TABLE B.3 - ATLANTIS Starboard Squirt Boom and Aft CTD Winch
Note: Some of the figures below are estimates for Appendix B illustration only.

GEOTRACES LHS - KNORR
Note: Some of the figures below are estimates and are provided for Appendix B illustration purposes only.

R/V ATLANTIS
(AGOR 25)

WHOI HYDROBOOM

Figure 1: Hydroboom, Plan View

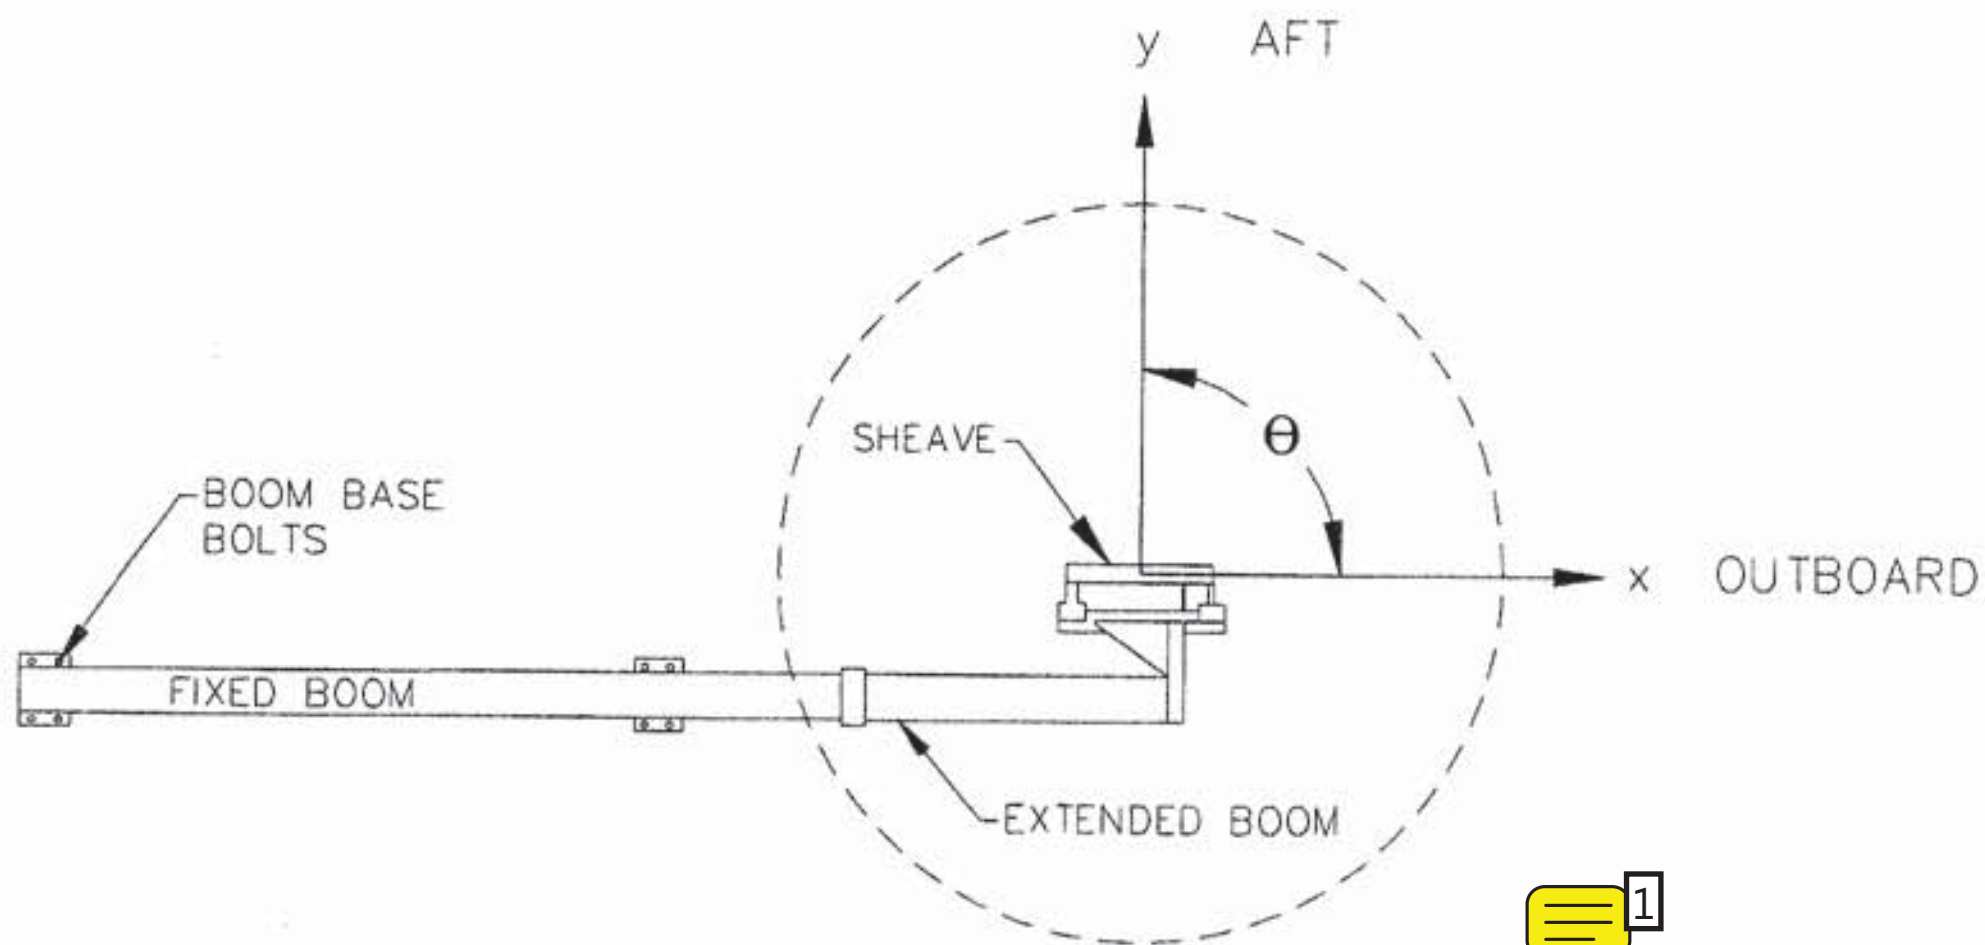
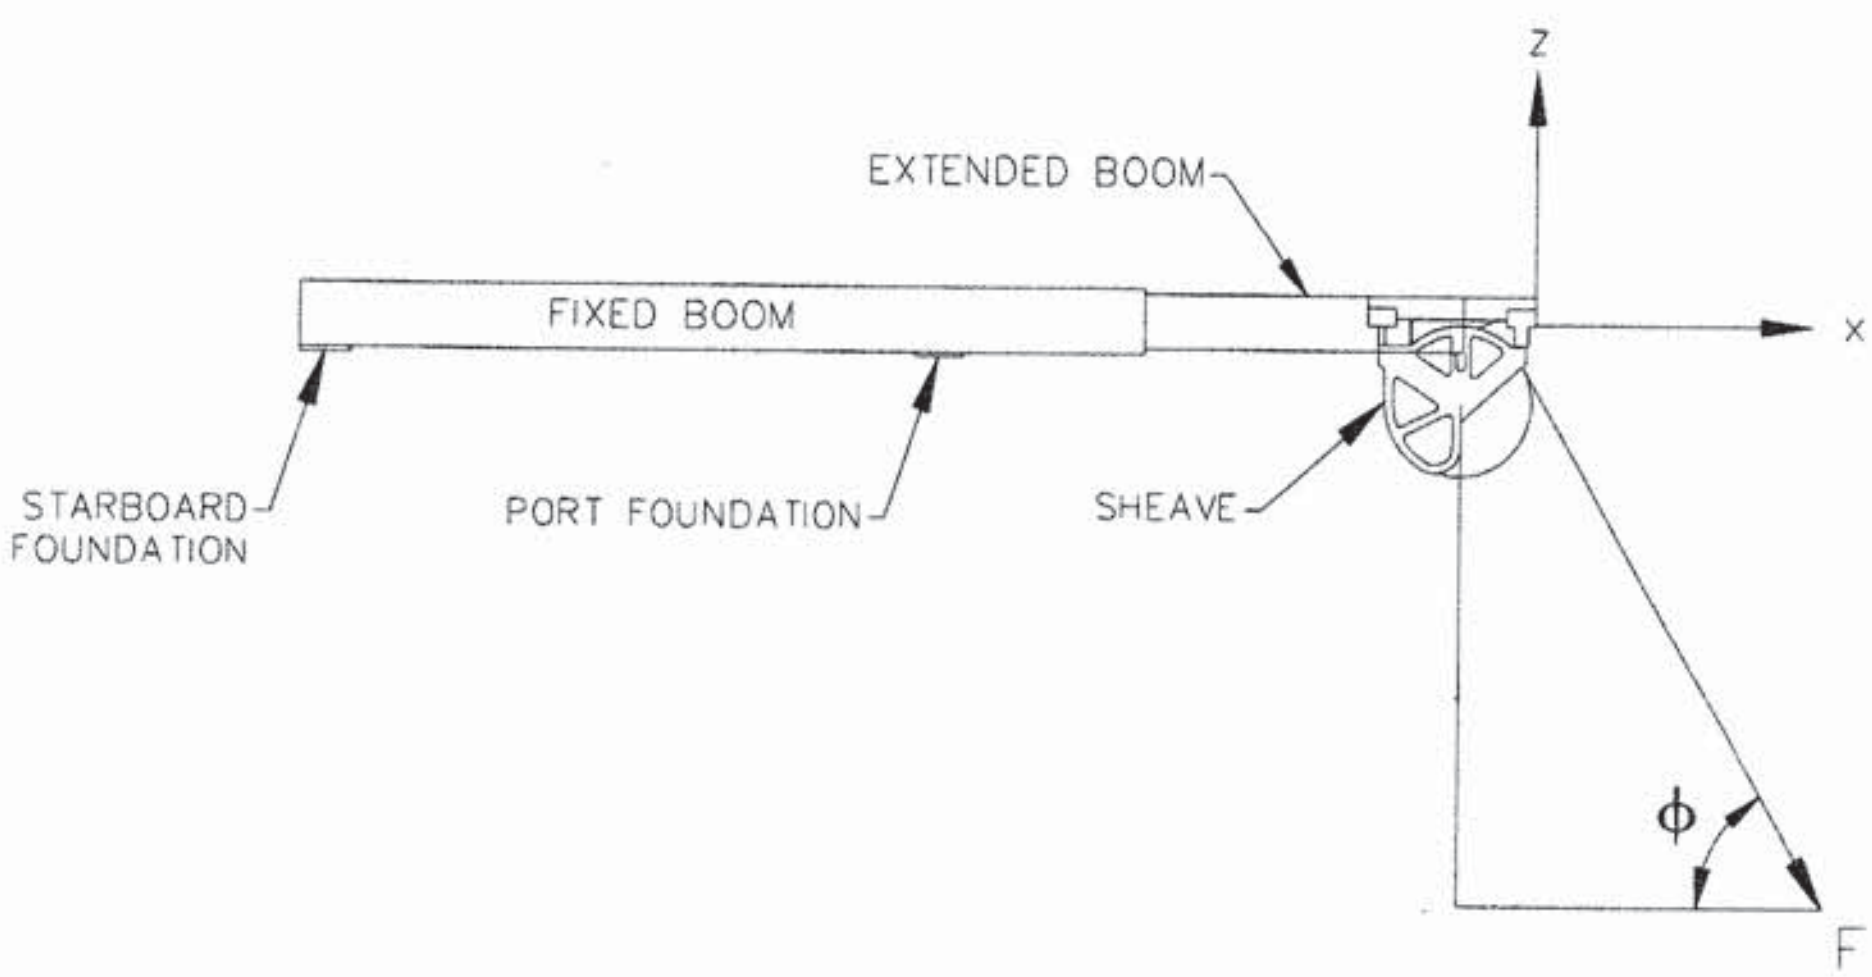
Excellent diagrams for inclusion in the MCD.

Figure 3: Hydroboom, Sheave Assembly

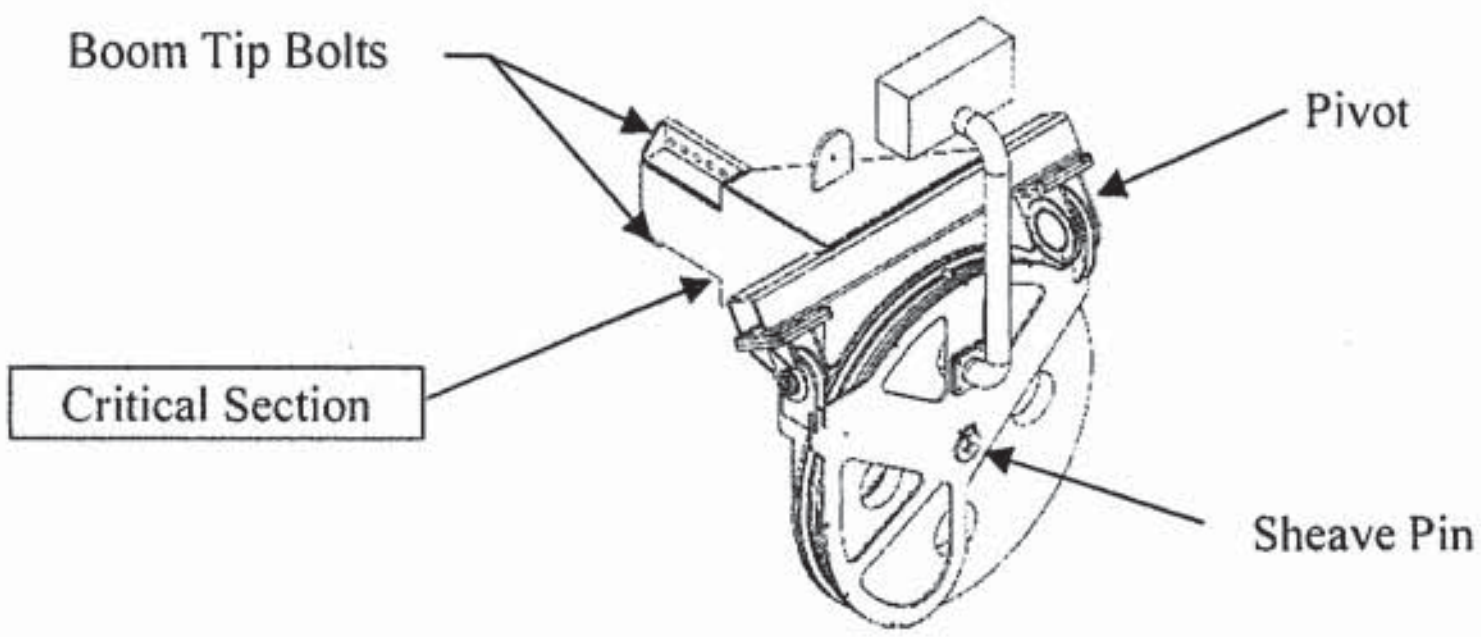
The support assembly itself has stresses exceeding the CFR limits. This occurs at the transition from the bolting flanges to the tapered beam section marked “critical section” in Figure 3. This calculation has stretched the capabilities of this analysis, and it would be best to ask the original designers of this structure to perform an FEA to confirm the values obtained with the spreadsheet. However, it appears that an FEA would not yield results which would pass the CFR criteria.

It is possible to envision a modification to the critical section of the support structure that eliminates the discontinuity at the bolting flanges; however, when combined with the need to add extra boom tip bolts and a padeye, it would be best to redesign and replace this section of the assembly entirely.

Figure 5: Boom Tim Bolting Modifications

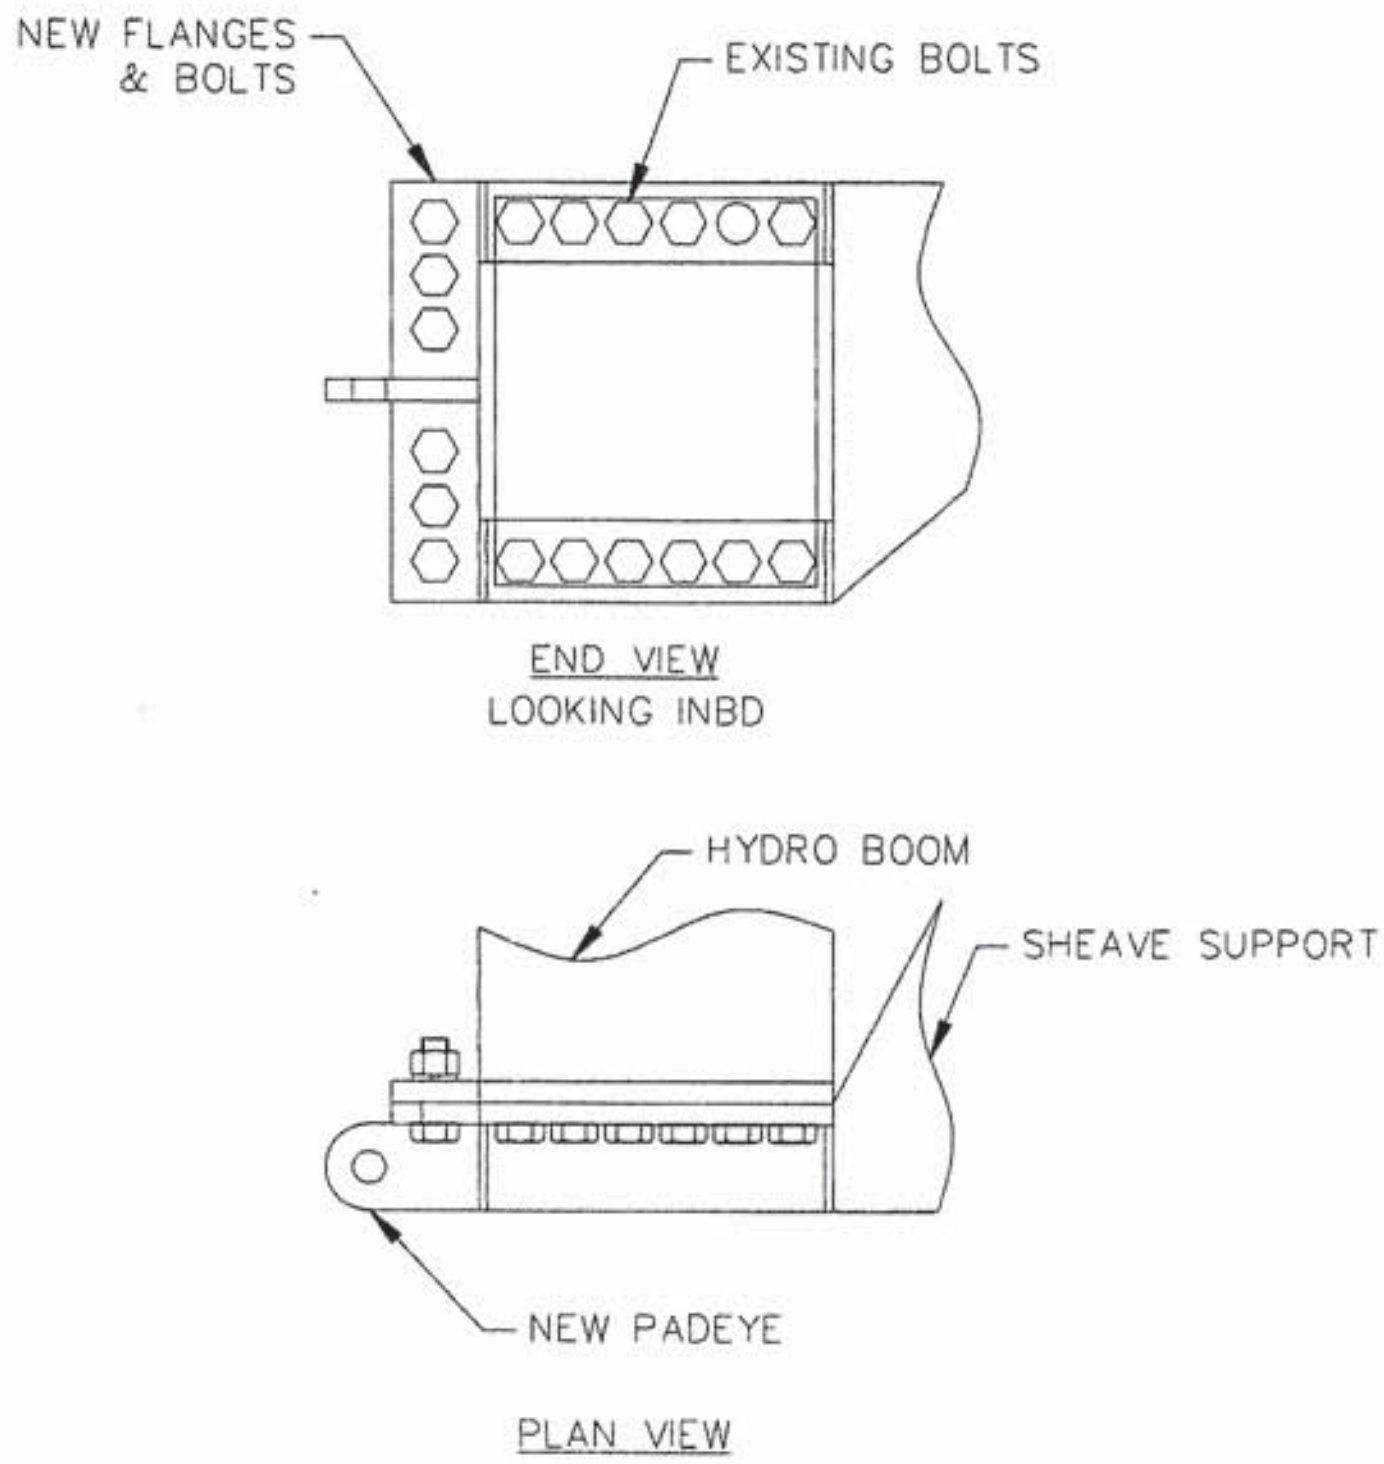
The existing boom tip bolt pattern has a row of bolts at the top and bottom. This provides little resistance to forces applied in the horizontal plane due to having the sheave cantilevered off the aft side of the boom. To better counter these forces, a vertical row of bolts may be added on the forward side of the boom tip. This will entail welding two mating flanges to the existing boom tip and sheave support structure. To accomplish this, the existing padeye will also have to be modified. During normal loading operations, the addition of six 1.25" diameter Grade 8 bolts in the proposed vertical orientation (see Figure 5) will allow the maximum wire breaking strength to be increased to 46 kips.

However, the stresses due to the towing condition are even higher. Solutions to counter the towing loads include designing an entirely new, larger, bolted connection for the boom end; or alternately, welding the sheave support structure to the end of the boom, which would obviate the need for the extra bolts.

Figure 6: Hydroboom Towing Configuration

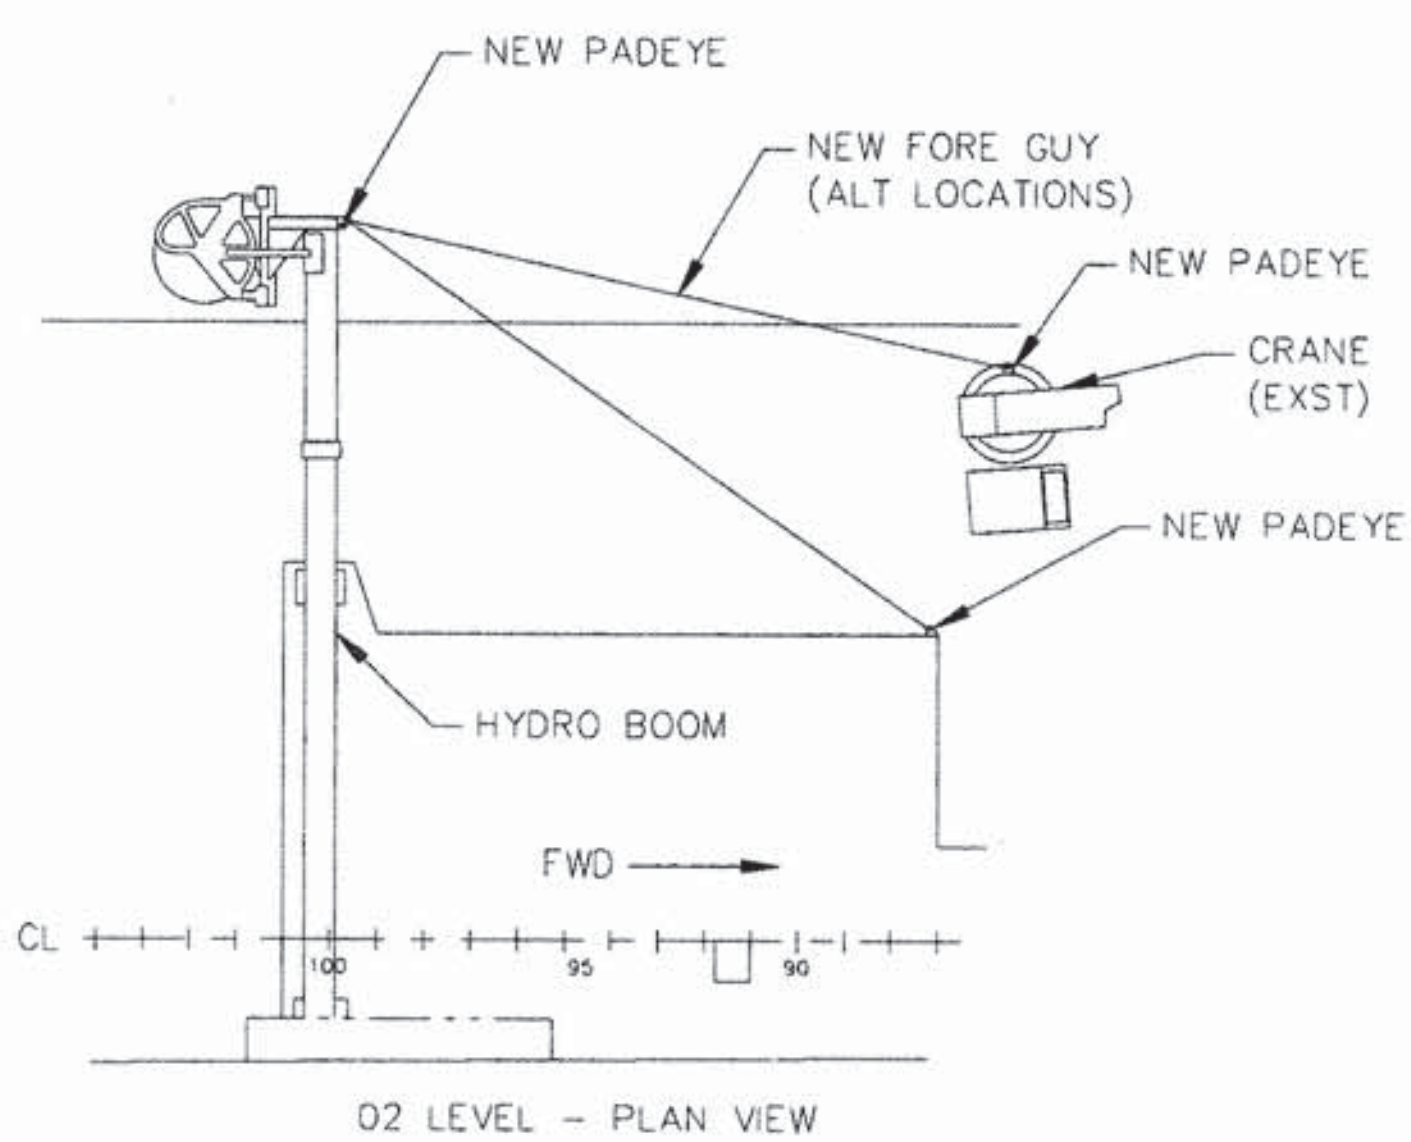
A padeye on the boom tip already exists, although it may need modifications, as described above. A fore guy taken from this padeye in a horizontal plane to the deckhouse or the crane base will decrease the moment in the horizontal plane, M_z. This will drop the stresses in the fixed and extended booms, and move them into the acceptable range for both normal conditions and towing conditions.

Port boom is not rated for towing unless stays are installed. It is unknown under what cable loads this will be required on the starboard boom until the MCD is developed. The ATLANTIS has not yet taken the steps to install the required padeyes and stays, but they have the necessary information.

Figure 7: Fixed Boom Modifications

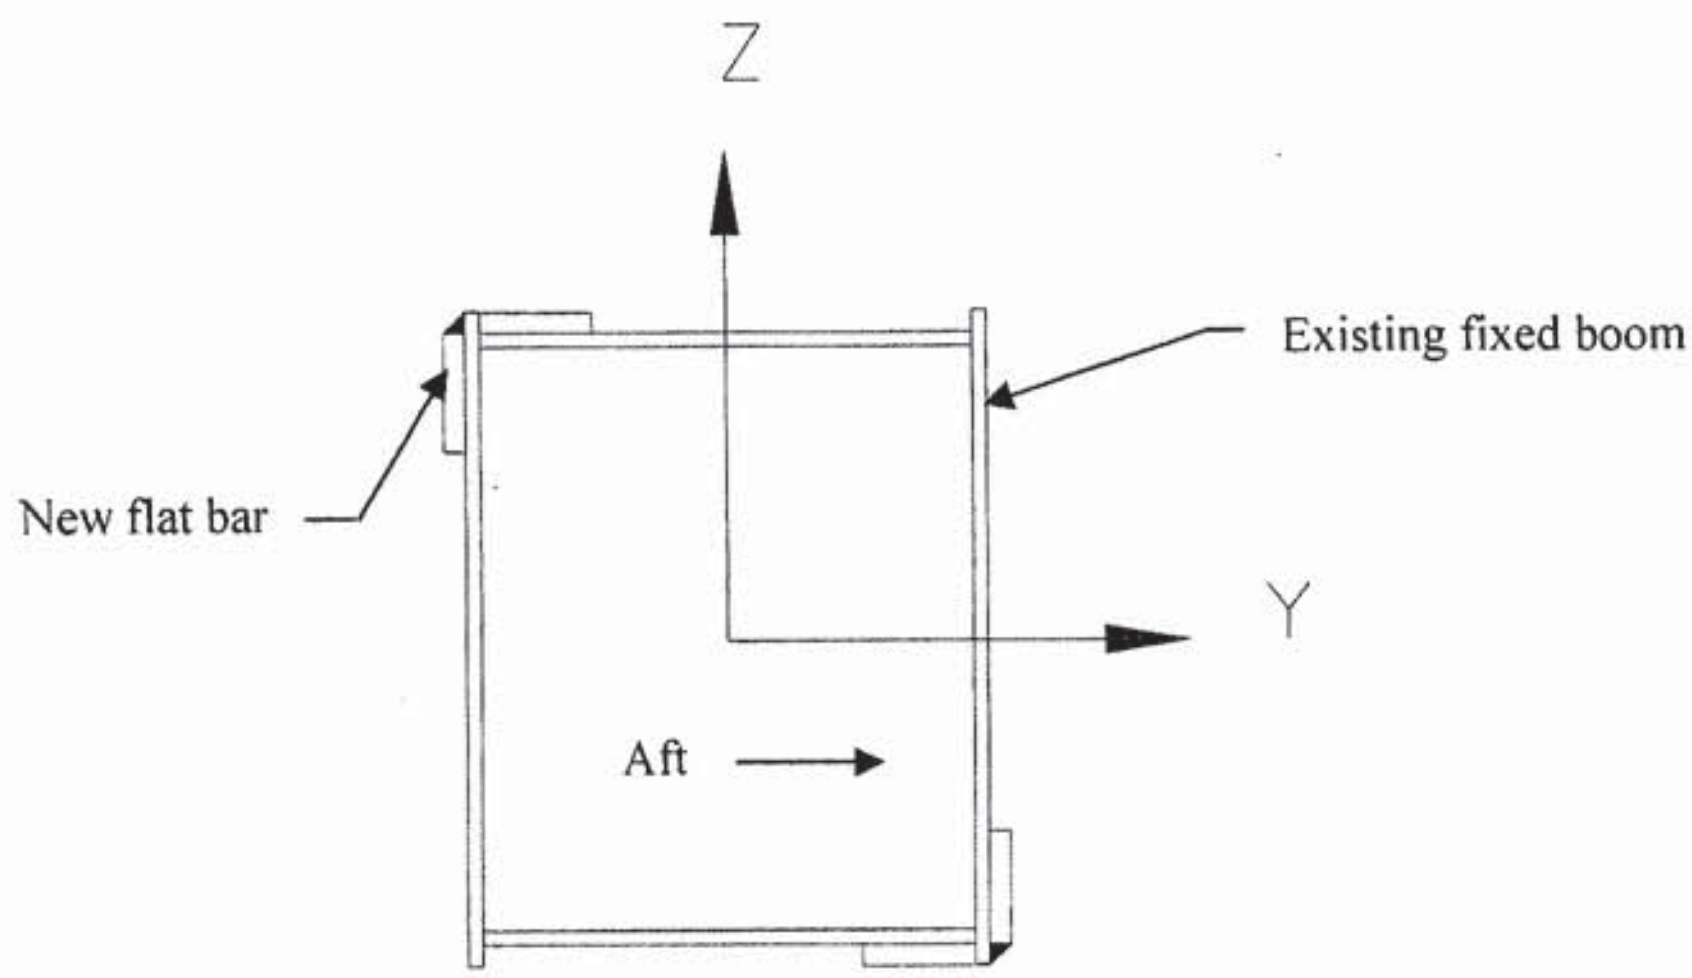
Because it is only desired to use the fore guy in towing situations, other solutions are examined for the fixed boom in normal operation. Flatbar doublers may be welded along both faces at the top forward and bottom aft corners of the fixed boom. Four 7" x 3/4" flatbars will bring the maximum wire breaking strength up to 46 kips (see Figure 7).
